PROPOSED ALTERATIONS

at 479 CHURCHILL AVENUE
for ANCHORAGE TASMANIA HOLDINGS PTY LTD

479 Churchill Avenue – New Development Application for Change of Use to Three Multiple Dwellings

479 Churchill Avenue, Sandy Bay
Change of Use to Multiple Dwellings
Additional Information

PROPOSED DRIVEWAY 1 - LONGITUDINAL SECTION (CENTRELINE)
SCALE HOR 1:100 VER 1:100 (A1)

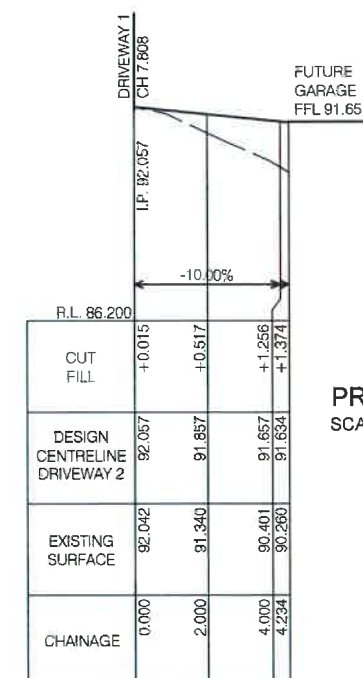
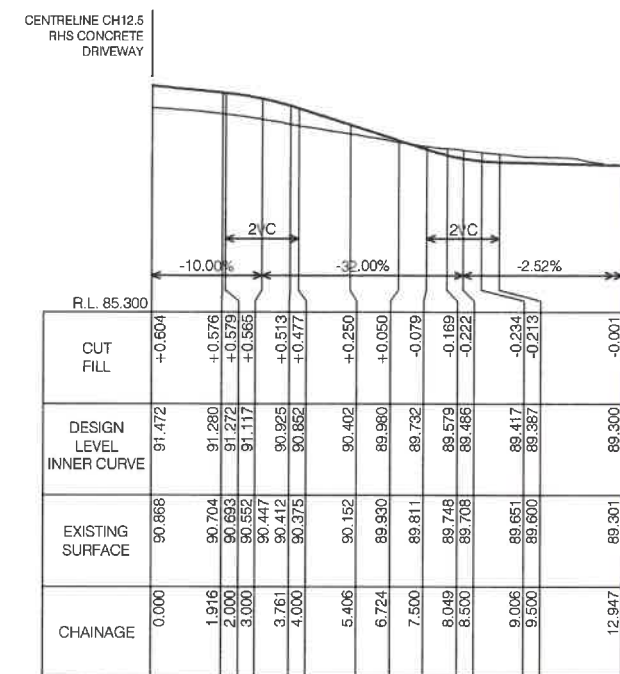
The drawings have been revised in accordance with the requests for further information from Council dated 1st November and 6th November 2017.

The layout and dimensions of the proposed car parking spaces are shown in sheets 4 and 5. The headroom is shown on sheet 3. These comply with AS 2890.1
